## ADDENDUM No. 2

**Project: 2024922**  
**South Jones High School Athletic Buildings**  
**Jones County School District**  
**Laurel, Mississippi**

The following additions, changes, clarifications, and substitutions to the drawings and specifications, dated June 25, 2025, are to be included as part of the contract documents. Acknowledge receipt of this addendum by inserting its number and date in the proposal form.

**1**  
**SOFTBALL FIELDHOUSE LOCKERS LAYOUT**  
A7.1 SCALE: 1/2" = 1'-0"

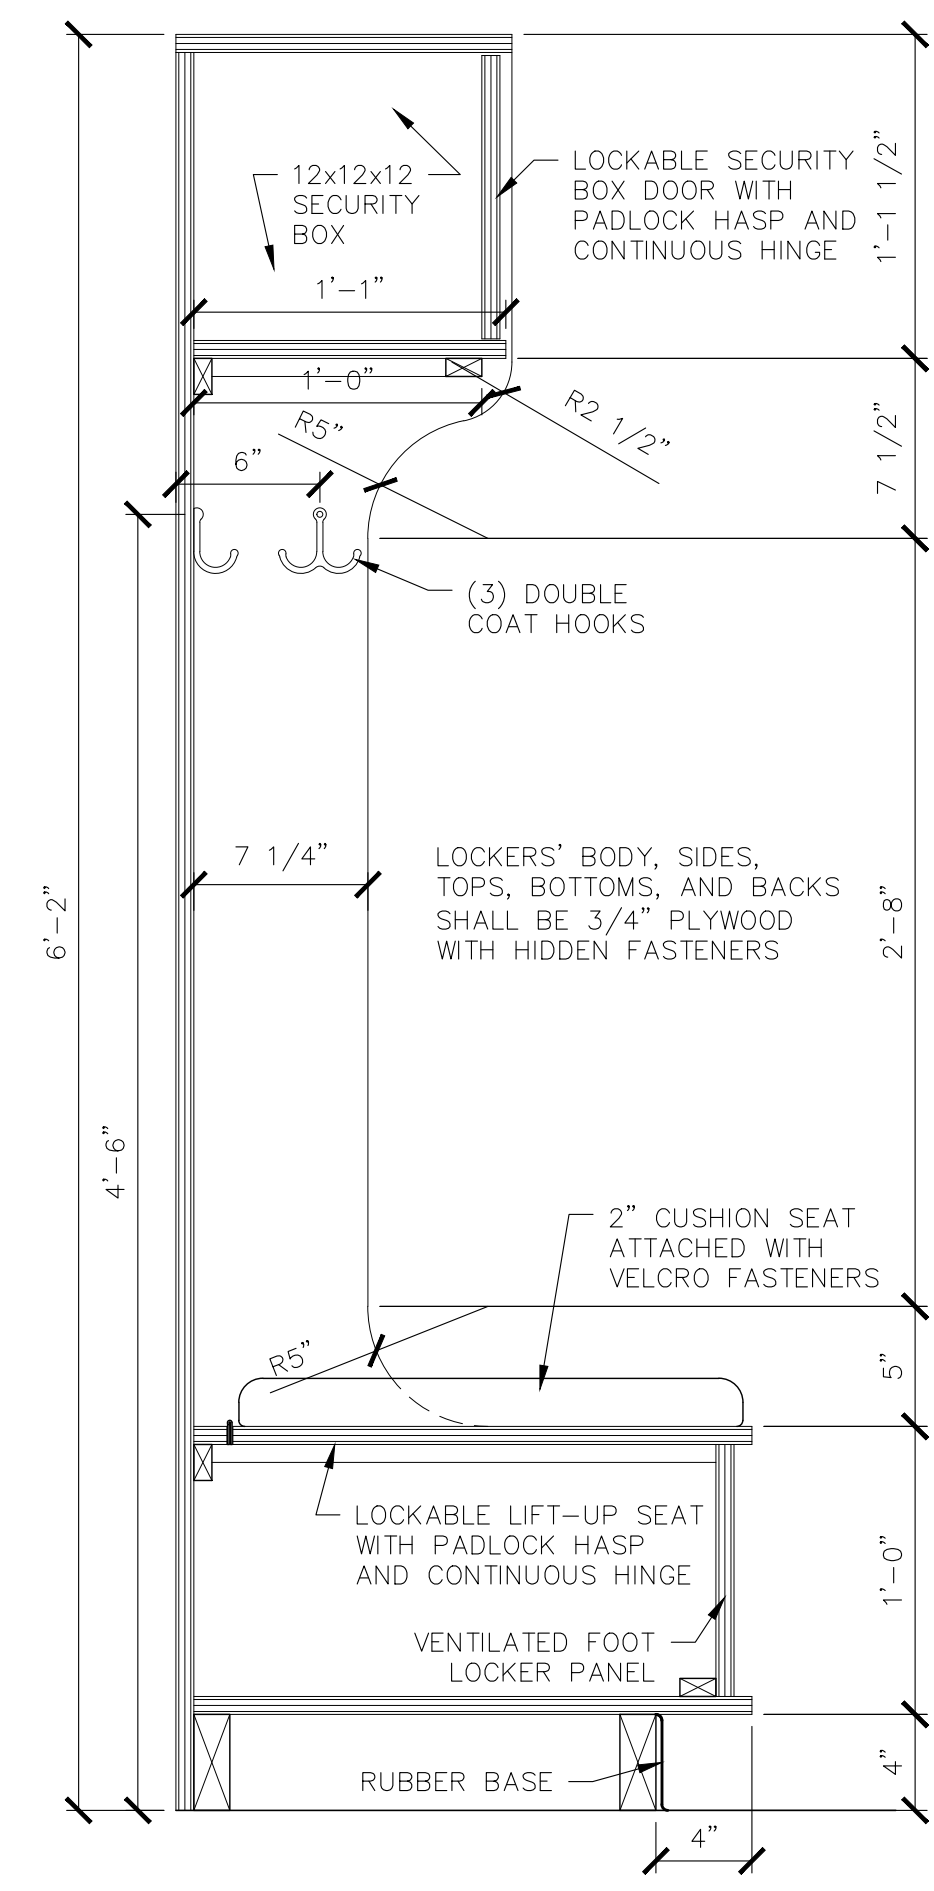
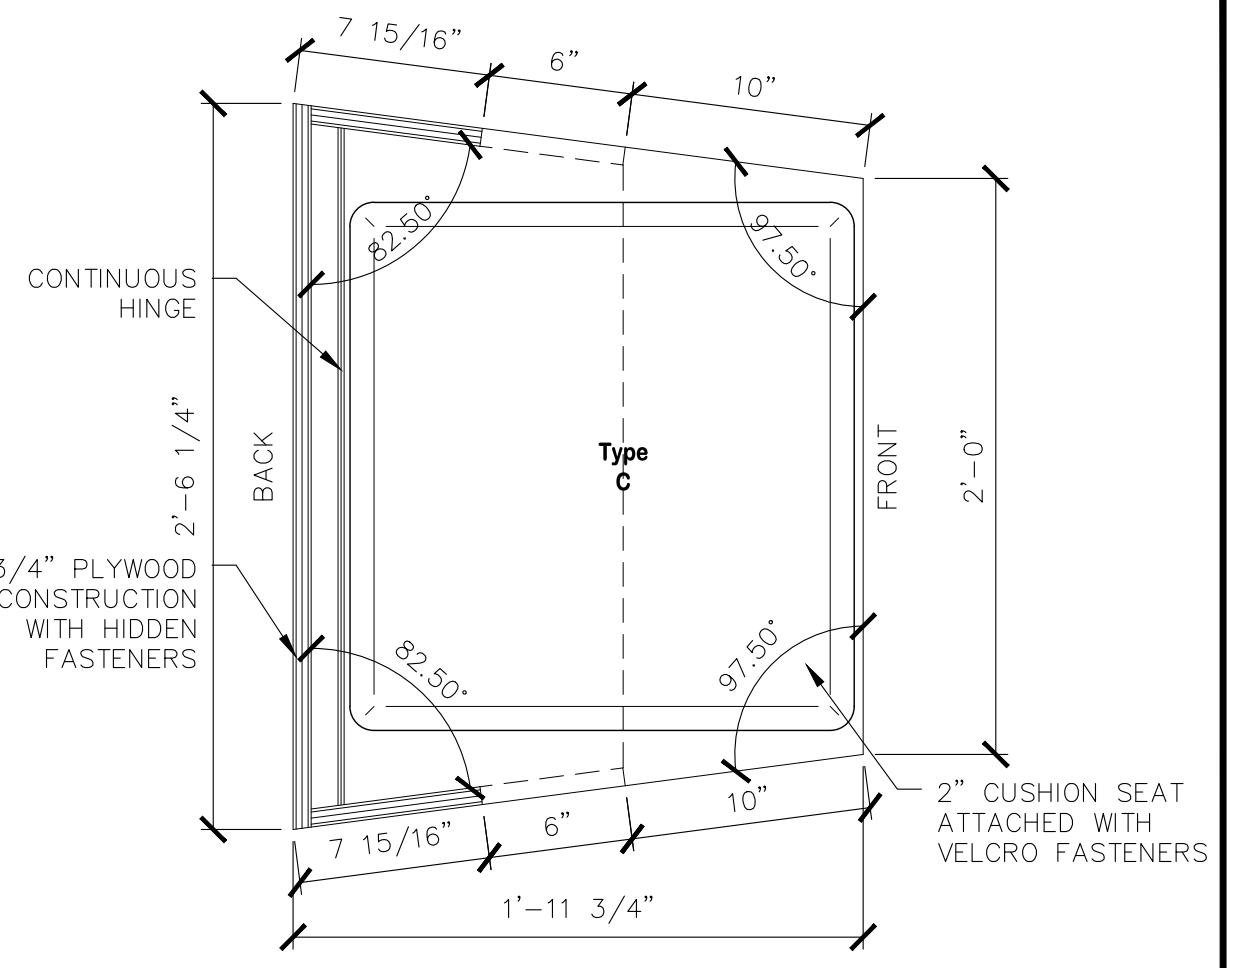
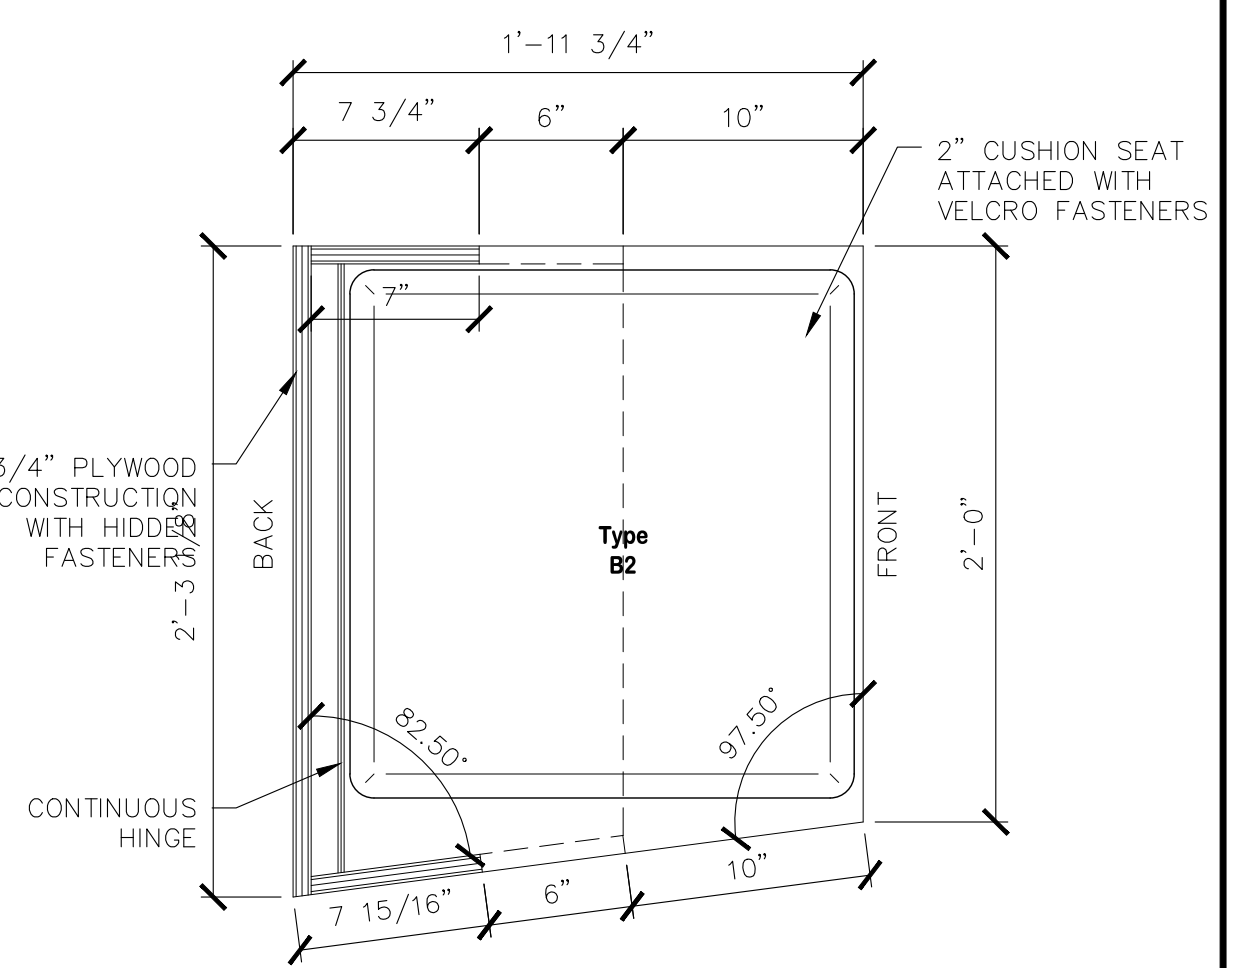
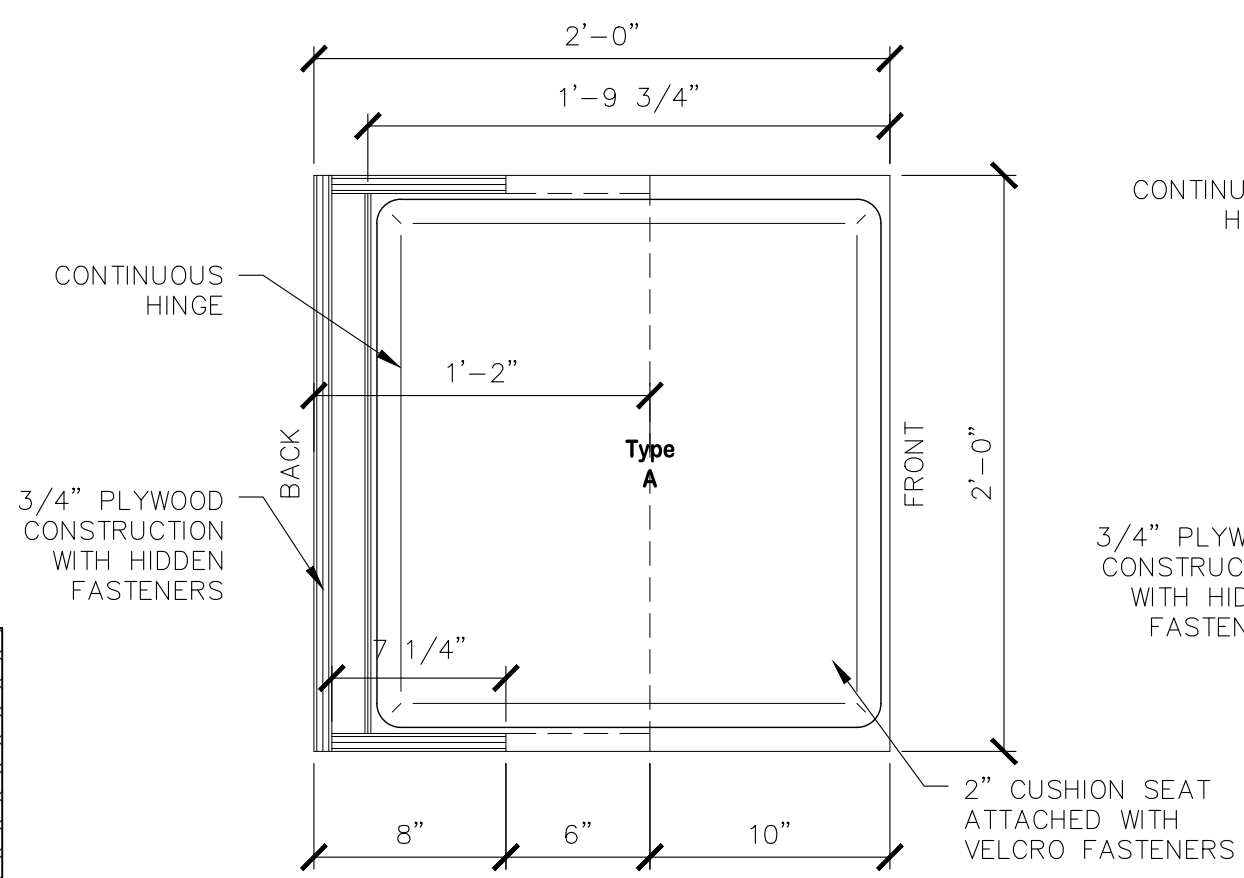
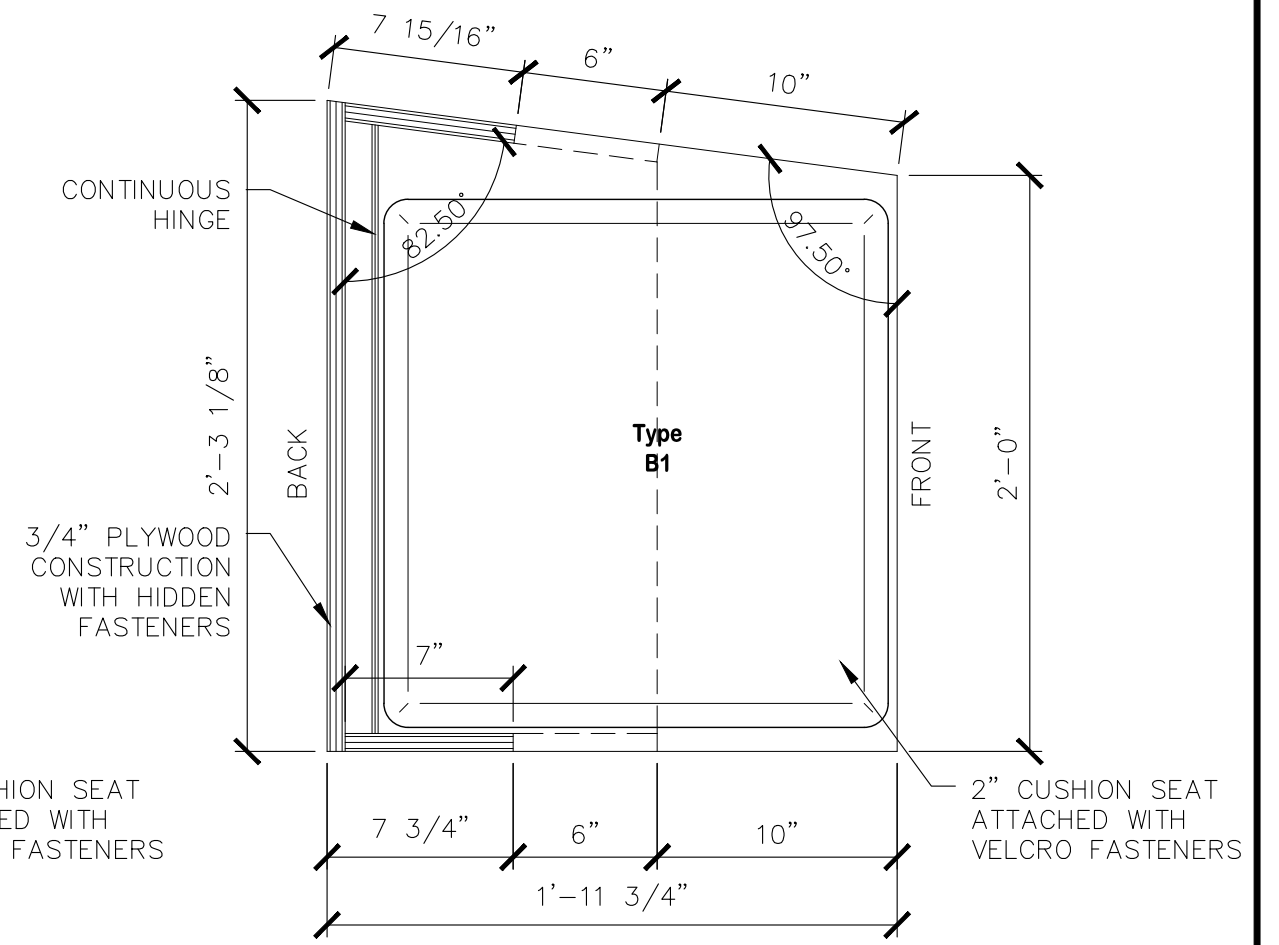
- Item No. 2. Refer to Project Manual – Add the enclosed Section 01 18 03 Project Utility Sources.
- Item No. 3. Refer to Project Manual – Add the enclosed Section 10 51 16 Athletic Wood Lockers. Athletic Wood Lockers shown on A7.1 and A7.2 shall be per enclosed Section 10 51 16 Athletic Wood Lockers.

- Item No. 19. Refer to Sheet A1.22, Plan 1/A1.22, Note 5 – Refer to enclosed A7.1 for Lockers' Layout and Details.
- Item No. 20. Refer to Sheet A1.22, Plan 1/A1.22, Note 6 – Coaches Lockers shall be Type A as shown on A7.1.
